ADDENDUM NO. 3

NIAGARA FALLS BRIDGE COMMISSION

RAINBOW BRIDGE DECK REPAIRS AND MISCELLANEOUS REPAIRS AT THE WHIRLPOOL RAPIDS AND LEWISTON-QUEENSTON BRIDGES

PROJECT #2016-02-2B

SHEET REFERENCE NUMBER
RB-111
SHEET 12 A3 OF 29

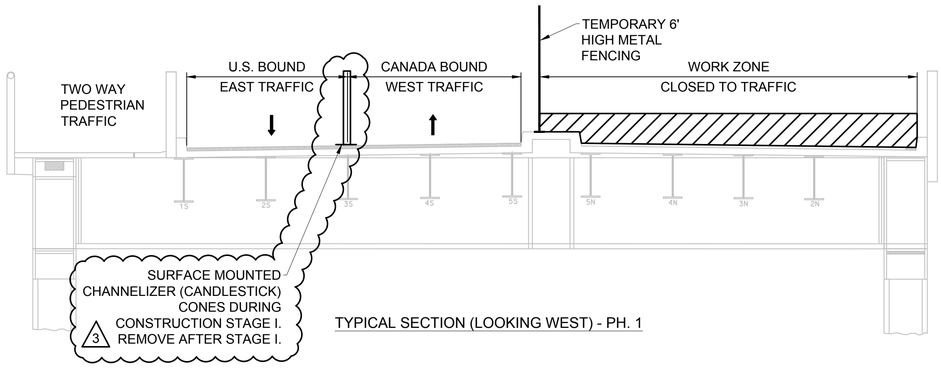
2.2 How will the contractor end the temporary barriers?
- 2.2.1 Sand barrels per NYSDOT 619 for posted speed limit can be used in lieu of a steel crash attenuator. See revised MPT (Maintenance and Protection of Traffic) plans RB-111, RB-112, RB-113

2.16.1 Yes. See revised MPT (Maintenance and Protection of Traffic) plans RB-111, RB-112, RB-113

4.9 Drawing – RB-111 MAINTENANCE AND PROTECTION OF TRAFFIC, STAGE 1, Sheet 12.A2
REPLACE *drawing in its entirety with revised drawing* ***RB-111, Sheet 12.A3*** *issue date* ***12 January 2018****, included in Addendum Drawings Section 5.0.*

1 RB101 DETAIL - SIDEWALK UTILITY HAND HOLE REPAIRS (TYP.)

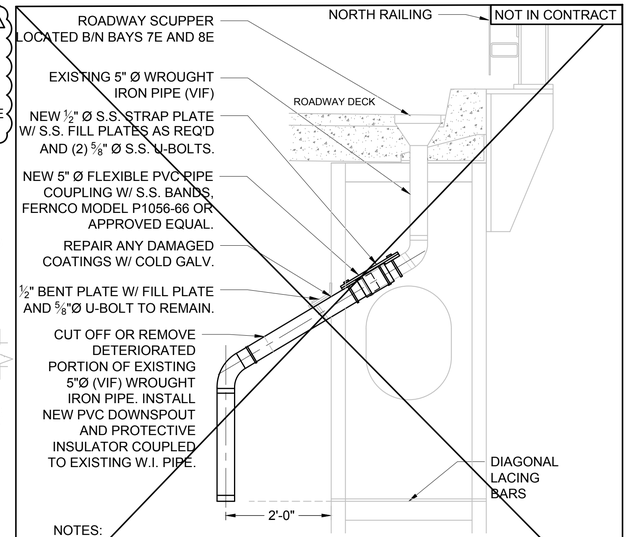
2.15.1 No, sidewalk plates (detail 5/RB503) and utility hand hole diamond plate covers (detail 1/RB502) both get anti-slip coating (Slip-not, Galvagrit, or approved equal) and then hot dip galvanizing.

REPLACE *drawing in its entirety with revised drawing* ***RB-502, Sheet 16.A3*** *issue date* ***12 January 2018****, included in Addendum Drawings Section 5.0.*
